Terrence J. DeWan & Associates  
Landscape Architects & Planners

November 30, 2018

**RE: RESPONSE TO LANDWORKS' REVIEW OF ROXWIND VISUAL  
IMPACT ASSESSMENT**

Figure 1

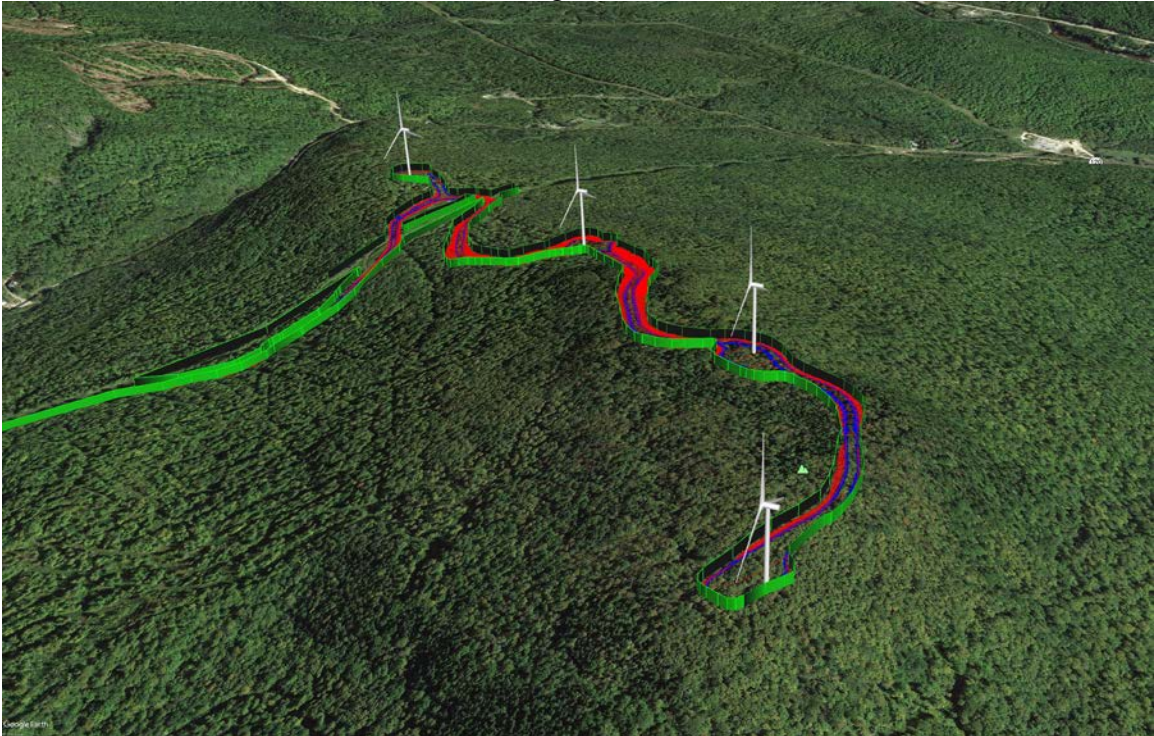
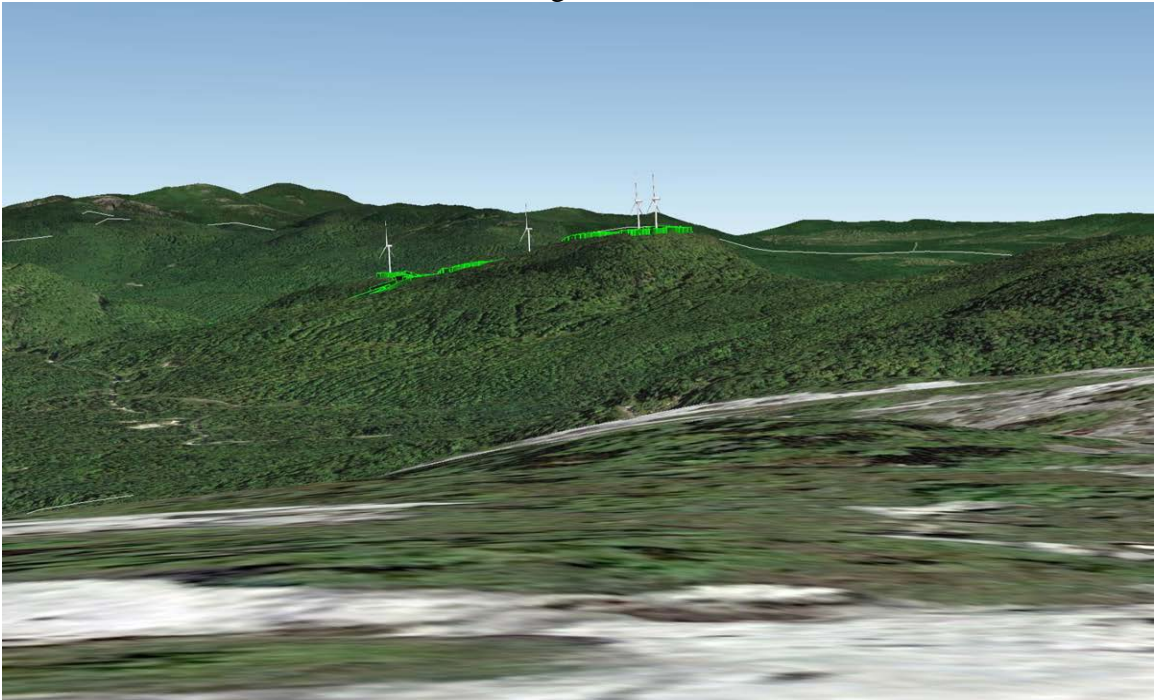
*C. There is a need for some additional analysis with regard to the visual effects of the associated facilities.*

limits of clearing, road plans from Stantec, assumed tree heights (40'), and other data to evaluate whether any of the cleared areas would be visible from SRSNS, and specifically Whitecap Mountain. Based upon this analysis, we determined that the access roads connecting the turbine sites, electrical collection system, crane pads, and crane assembly area will not be visible from any SRSNS.

A sample of the three-dimensional computer model is included below as Figures 1 and 2 to demonstrate how topography and existing vegetation will screen views of the associated facilities. LandWorks' comments on limits of grading, slope stabilization, and related matters are best addressed by the Project's civil engineers (who have considerable experience in dealing with wind energy projects in similar field conditions), as these topics are not typically within the scope of a VIA.

This model view shows the proposed 3D turbines, the edge of the proposed gravel access road in blue, the proposed grading in red, and the edge of clearing limits as 40-ft high green 'tree walls'.

This model view shows how the 40-ft high green 'tree walls' will screen the associated facilities from the Rumford Whitecap Mountain summit.
